MEMORANDUM

Subject: Addendum to MovingAhead Alternatives Analysis Technical Reports

This document is an addendum to the MovingAhead Project's Alternatives Analysis (AA) Draft Final Technical Reports, dated May 2017. This addendum serves to provide new options for mitigating potential adverse effects as related to the information gathered by the AA Technical Reports.

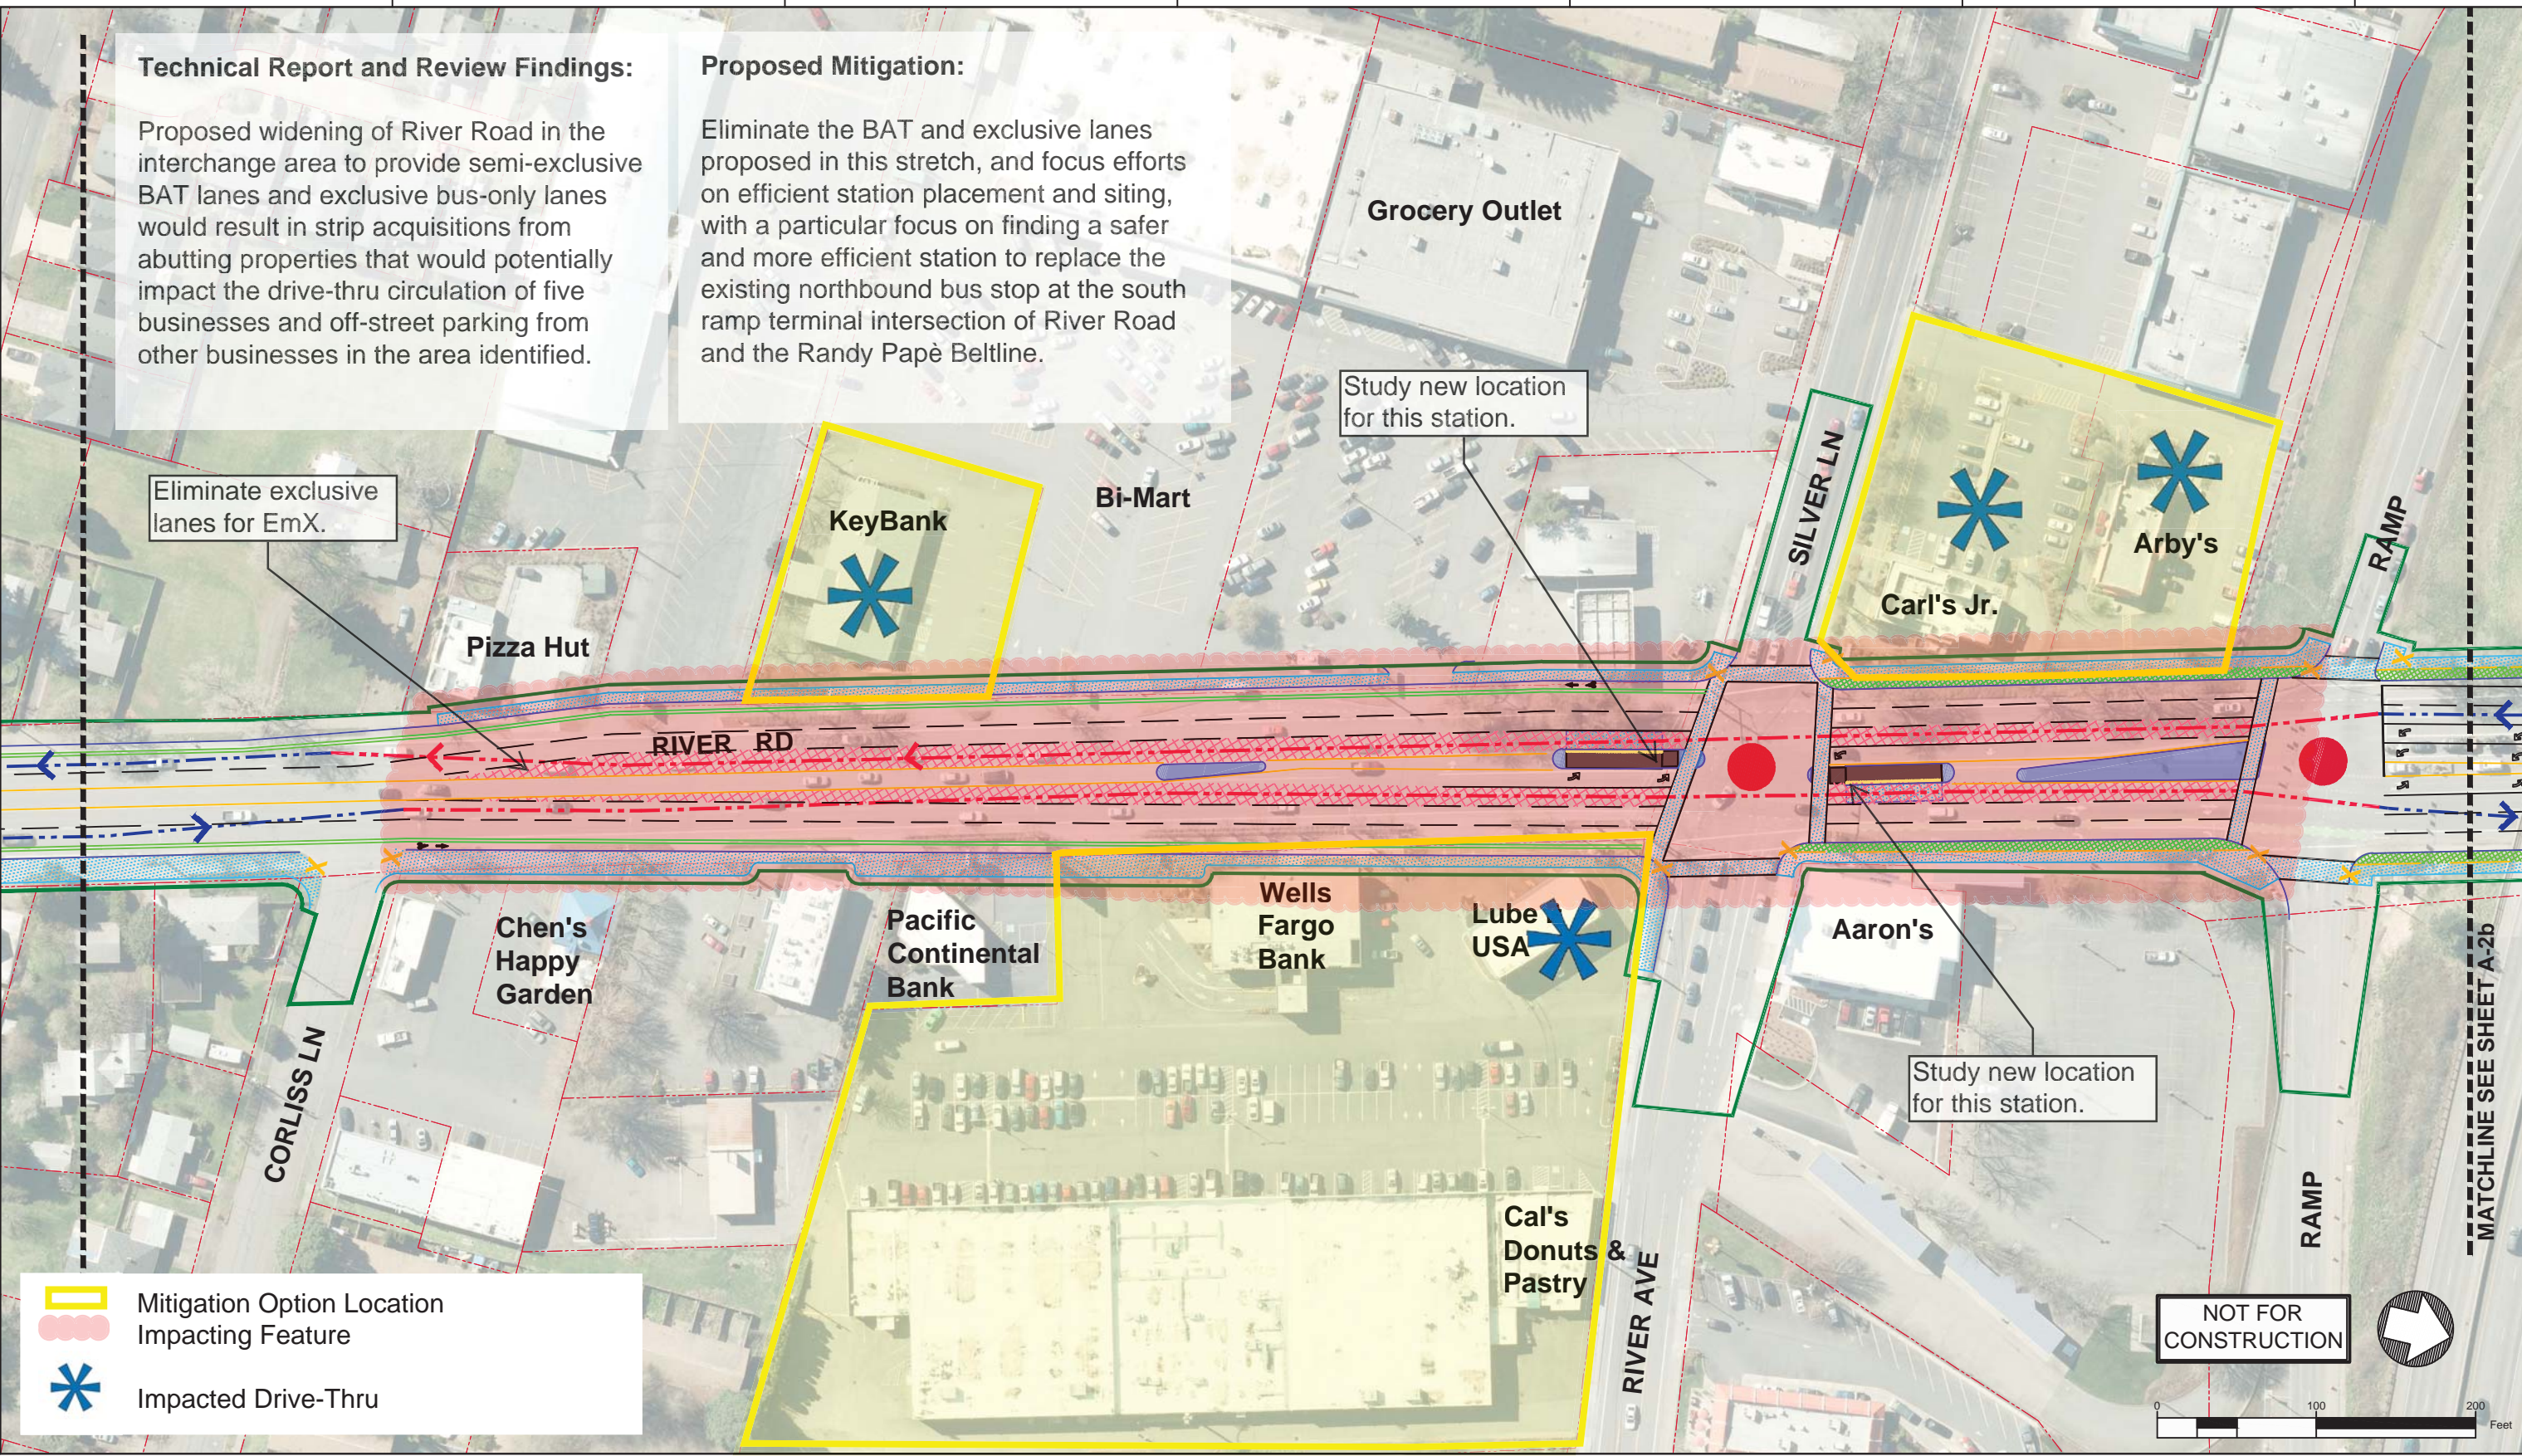
Proposed widening of River Road in the interchange area to provide semi-exclusive BAT lanes and exclusive bus-only lanes would result in strip acquisitions from abutting properties that would potentially impact the drive-thru circulation of five businesses and off-street parking from other businesses in the area identified.

Eliminate the BAT and exclusive lanes proposed in this stretch, and focus efforts on efficient station placement and siting, with a particular focus on finding a safer and more efficient station to replace the existing northbound bus stop at the south ramp terminal intersection of River Road and the Randy Papè Beltline.

Eliminate exclusive lanes for EmX.

RIVER ROAD CORRIDOR
EmX ALTERNATIVE

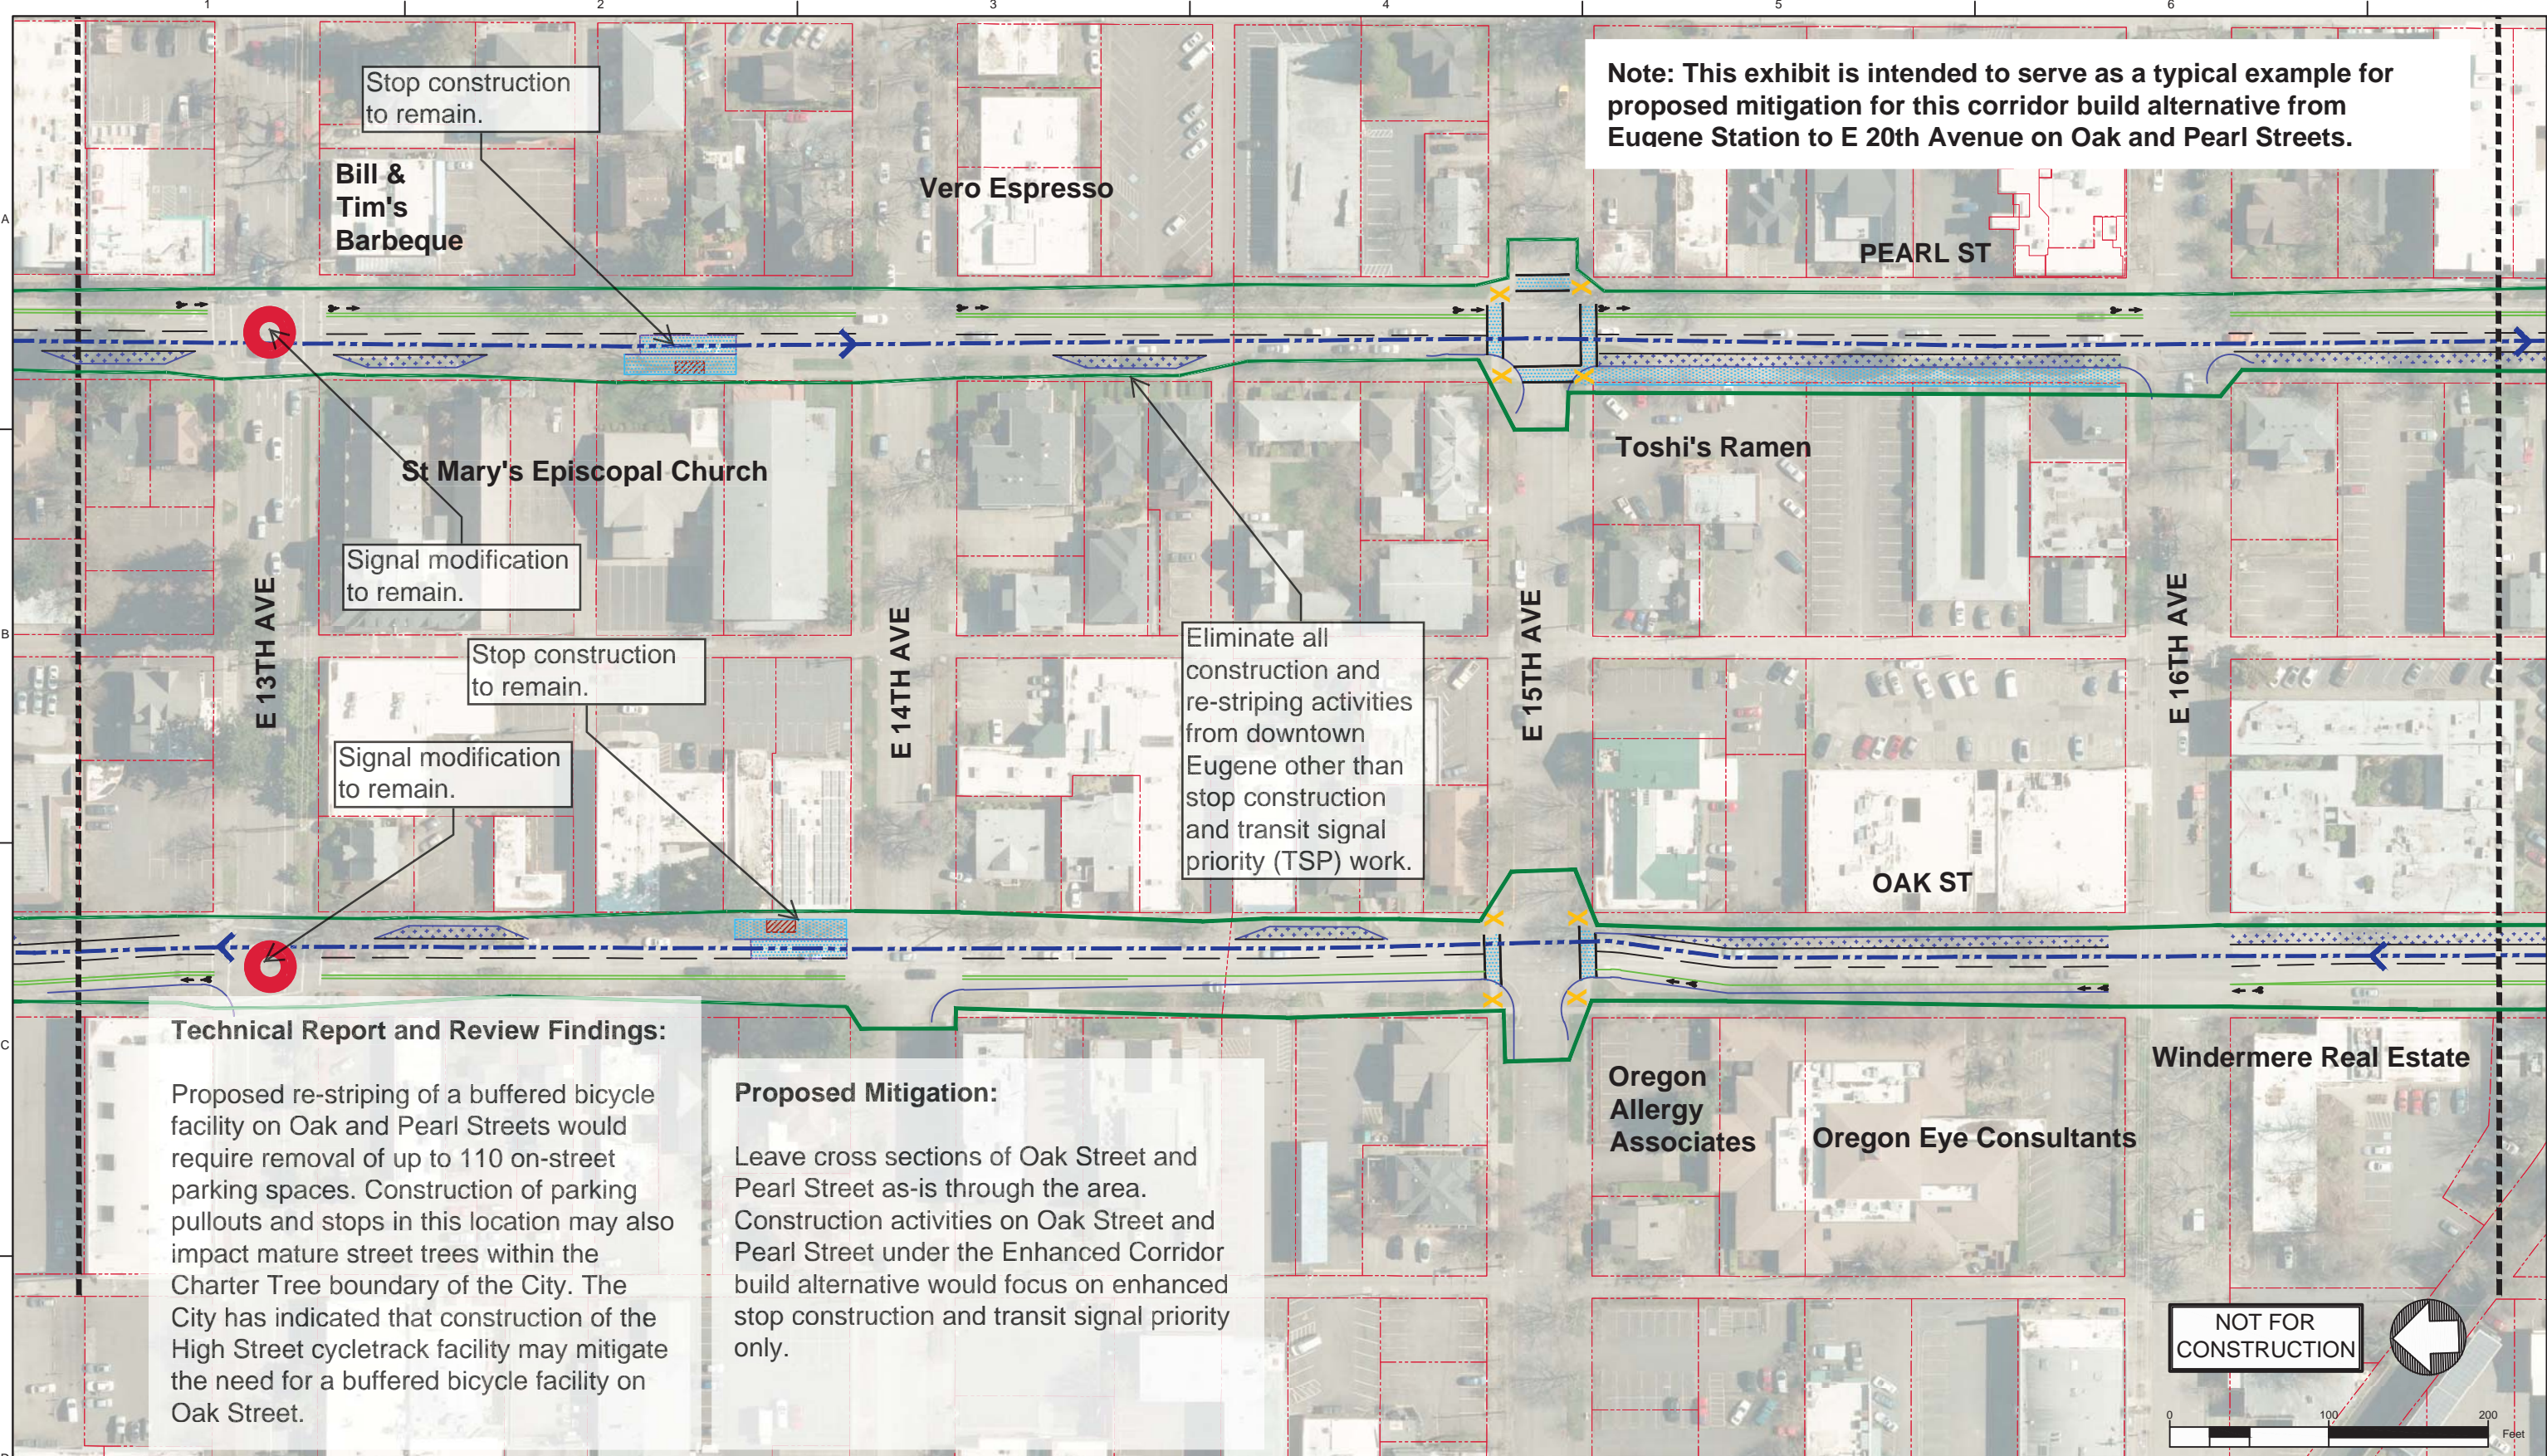
Proposed widening of River Road in the interchange area to provide semi-exclusive BAT lanes and exclusive bus-only lanes would result in strip acquisitions from abutting properties that would potentially impact the drive-thru circulation of five businesses and off-street parking from other businesses in the area identified.

Eliminate the BAT and exclusive lanes proposed in this stretch, and focus efforts on efficient station placement and siting, with a particular focus on finding a safer and more efficient station to replace the existing northbound bus stop at the south ramp terminal intersection of River Road and the Randy Papé Beltline.
